Value Engineering Study  
**US60 RECONSTRUCTION**  
BALLARD & MCCrackEN COUNTY, KY

ITEM NUMBER 1-115.00 & 1-115.10  
VE STUDY NUMBER 201109

**VALUE ENGINEERING STUDY  
for  
Kentucky Transportation Cabinet  
Frankfort, Kentucky**

**Draft Report**

Sketch of US60 189+00 Culvert Modification West of Industrial Boulevard

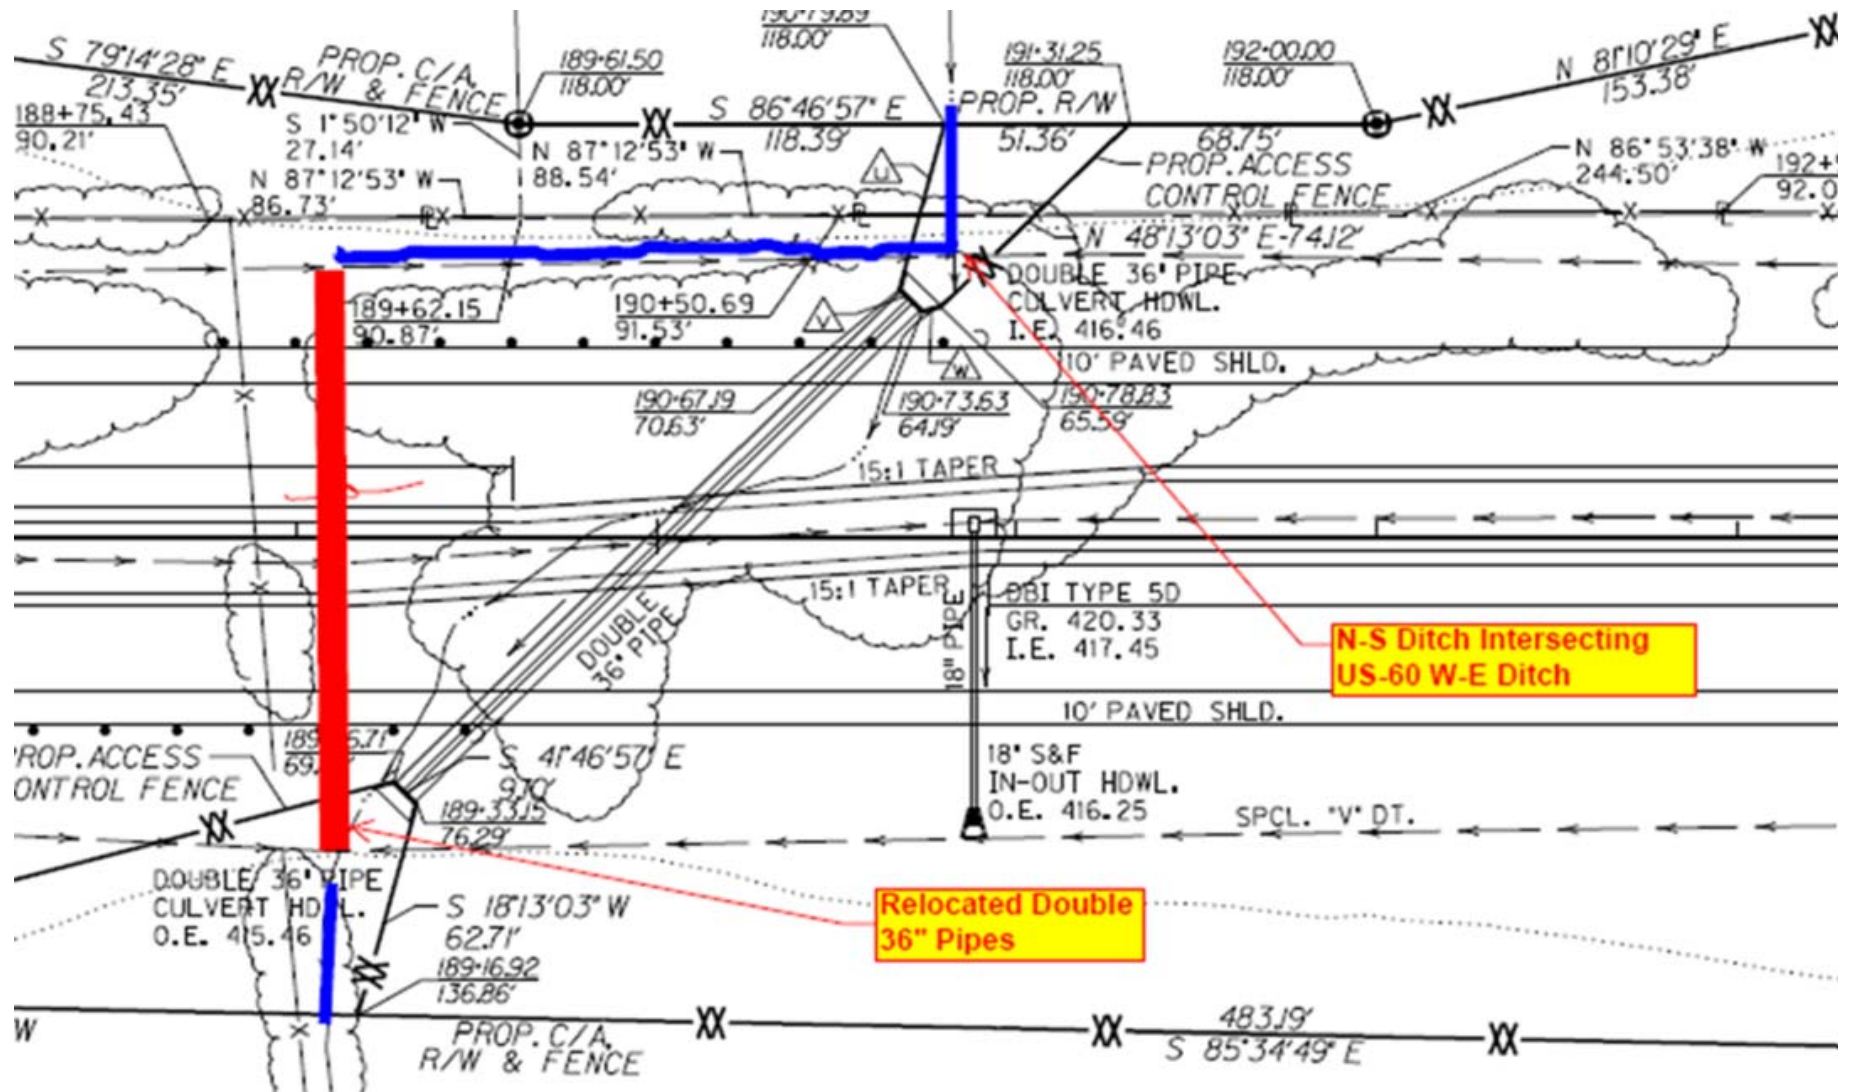
US60 Station 189+00 – The double barrel 36-inch culverts are straightened and travel to the bottom of the barn roof slopes, therefore allowing for the elimination of guardrail.

Sketch of US60 204+00 Culvert Modification and Stream Relocation East of Industrial Boulevard

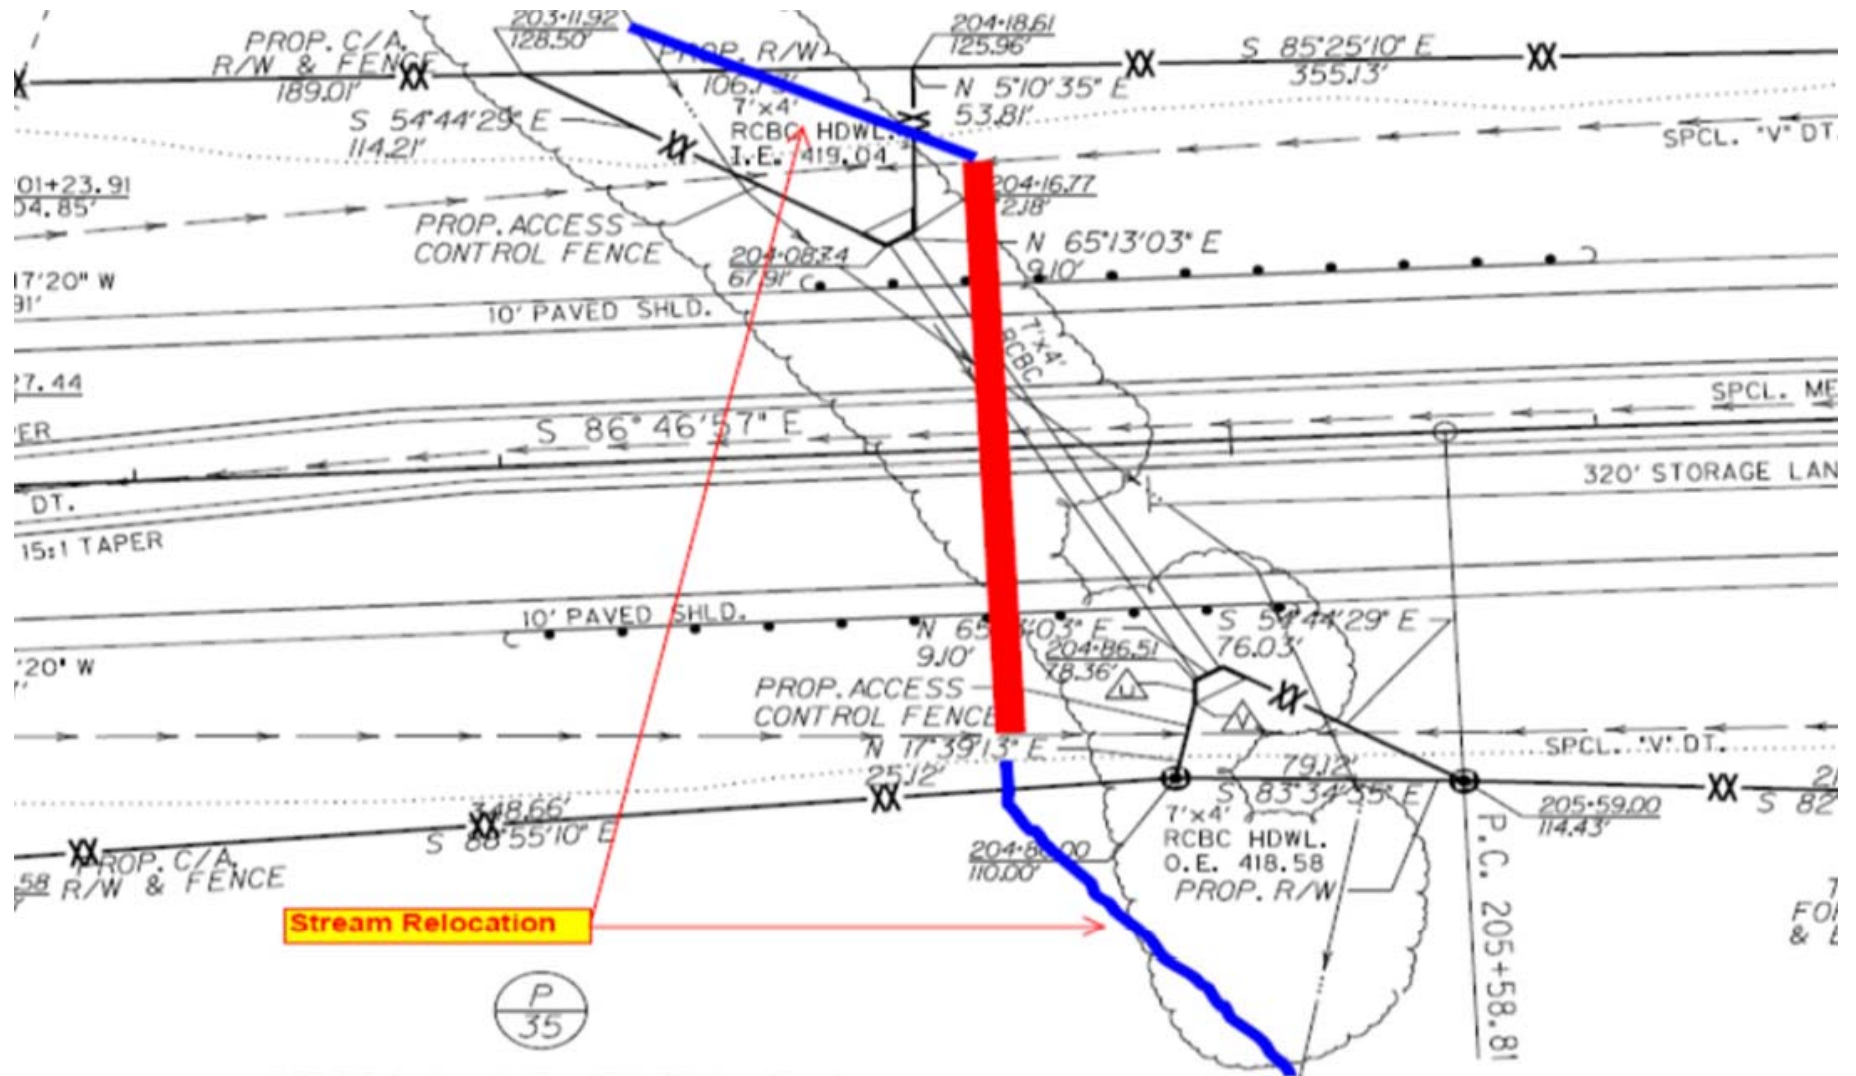
US60 Station 204+00 – The box culvert is straightened and travels to the bottom of the barn roof slopes, therefore allowing for the elimination of guardrail.

**Original Design: 4 lanes with depressed grass median**

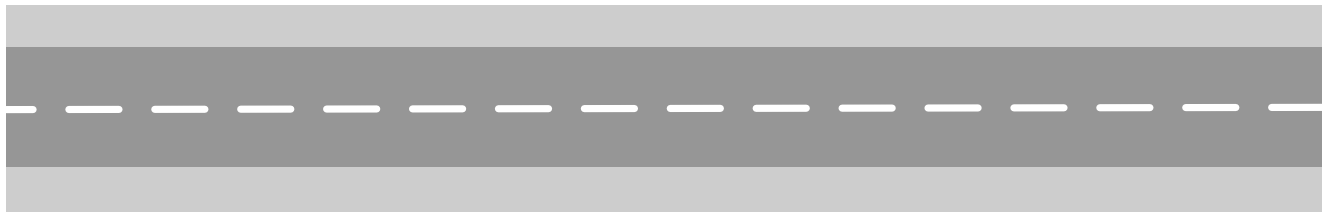
The traffic forecast was done in 2003 on based volumes from 2002. The current traffic counts in this area show that volumes have remained stable with very low growth. For example, the traffic count in 2011 just west of Wren Road was 8,104 vehicles per day (VPD) and the 2002 base count was 8,300 VPD. In addition, the forecasts show that the peak ADT for this roadway to be only 13,620 VPD. The current counts and the forecast only demonstrate a need for a two-lane roadway.

Reconstruction of a two-lane roadway on new alignment (same alignment used in the original design) would allow for the construction of turning left turn lanes at intersections and the control of access which provides for safer and more efficient driving conditions. This alternative is substantially less in construction and right-of-way costs compared to the original design.

**Original Design: 4 lanes with depressed grass median**

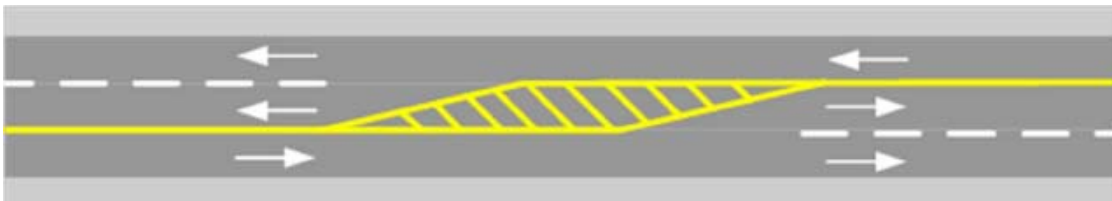
This alternative changes the pavement cross section to a 2+1 roadway configuration. By implementing this, the level of service for the roadway will be higher than the original design. Per the definition in the Highway Capacity Manual 2010 (Chapter 15), this route, after being upgraded would be classified as a Class 1 two-lane highway. For Class 1, LOS is determined by two measures of effectiveness:

This alternative addresses capacity and safety needs and is substantially less in construction and right-of-way costs compared to the original design. This design is proposed with 12 ft travel lanes and 8 ft paved shoulders.

Examples of potential modifications to access management design

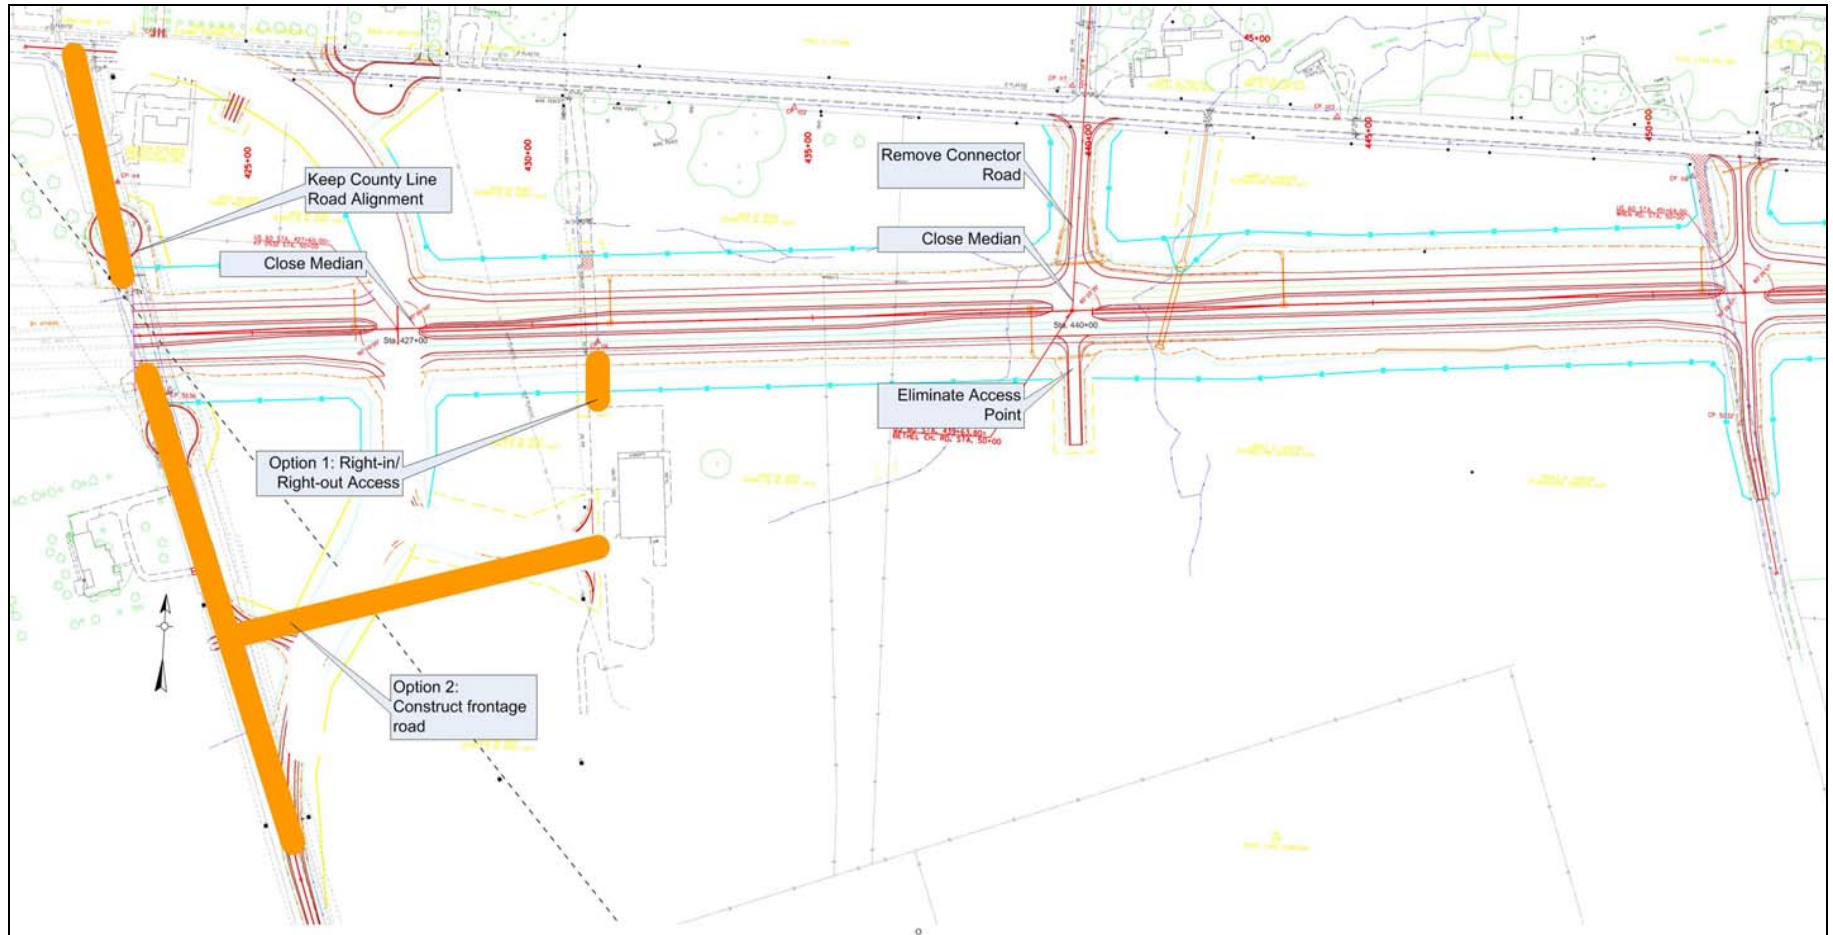
Review access control plan to consolidate and reduce the number of access points and median openings.

A.	130+00	Close median opening; make Sullivan Lane right-in/right-out; Sullivan Lane also has access on existing US60.
B.	164+00	Close median opening; remove realignment of Pine Lane and make right-in/right-out; Pine Lane also has access on existing US60

H.	467+00	Remove frontage road on the south side. Create right-in/right-out. This would be a way to save cost with little effect on traffic operations.

I.	490+50	On the north side, remove the frontage road and make the property right-in/right out with no median opening.

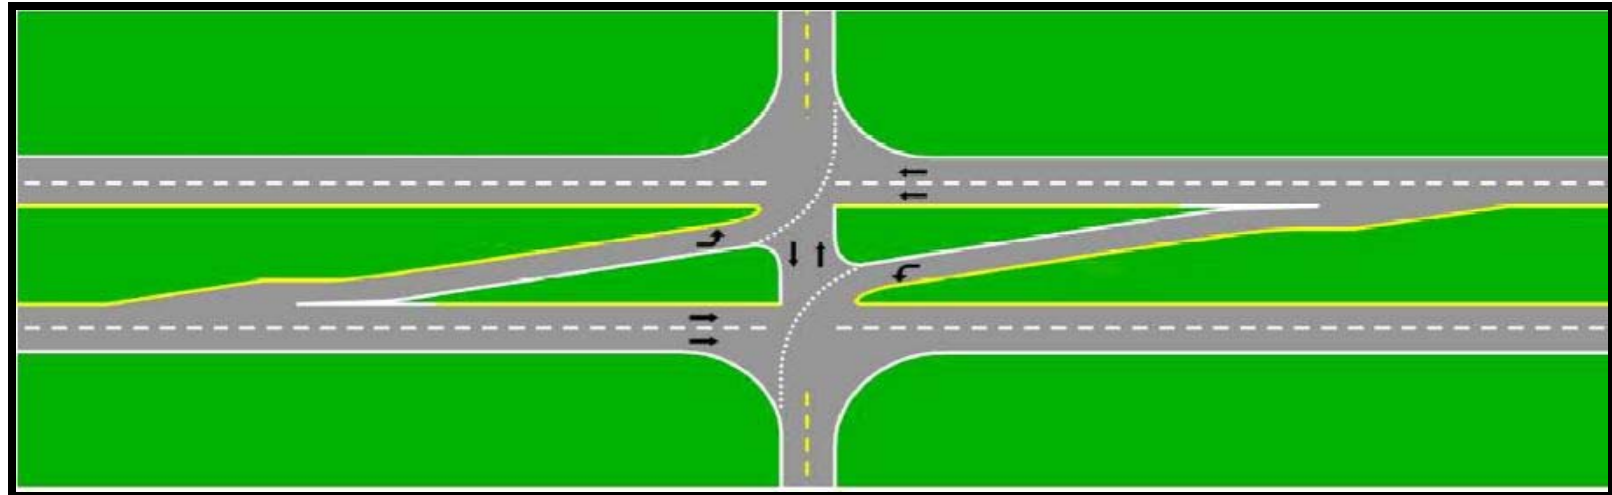
Construct offset left turn lanes in lieu of standard left turn lanes.

The original design includes left turn lanes at the median opening which are immediately adjacent to the travel way. Recent research has shown that offsetting the left turn lane can provide safety benefits due to improved sight distance. The basis for this is vehicles in the left turn lane at an at-grade intersection can block the view of left-turning vehicles from the opposite direction. The offset turn lane adjusts the alignment of vehicles making left turns from the highway so motorists can better see the vehicles around them, thereby making a safer left turn. Included below are some illustrations which help to visualize this concept.
